<b>SUNDRY NOTICES AND REPORTS ON WELLS</b> (DO NOT USE THIS FORM FOR PROPOSALS TO DRILL OR TO DEEPEN OR PLUG BACK TO A DIFFERENT RESERVOIR. USE "APPLICATION FOR PERMIT" (FORM C-101) FOR SUCH PROPOSALS.)		WELL API NO. 30-015-20103

2. Name of Operator Melrose Operating		6. State Oil & Gas Lease No.
3. Address of Operator 20333 State Highway 249, Suite 310, Houston, Texas 77070		7. Lease Name or Unit Agreement Name Vandeventer State

Propose to P&A

# WELL DIAGRAM

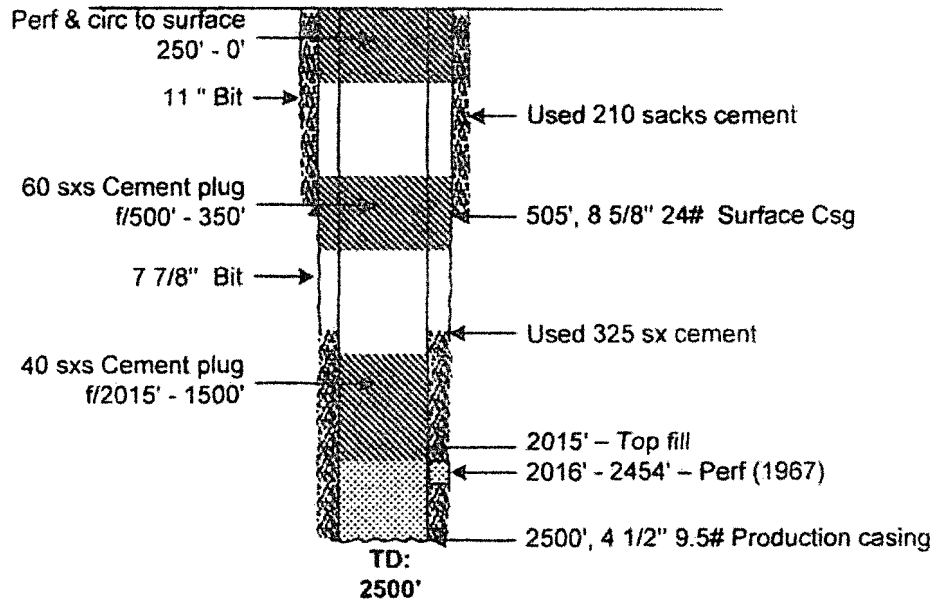
\* Set 60sx cement plug from 500' - 350' tag plug 555' - 350'

\* Cement from 50' below csg. shoe  
→ After isolating perfs, circ. hole w/plugging mud
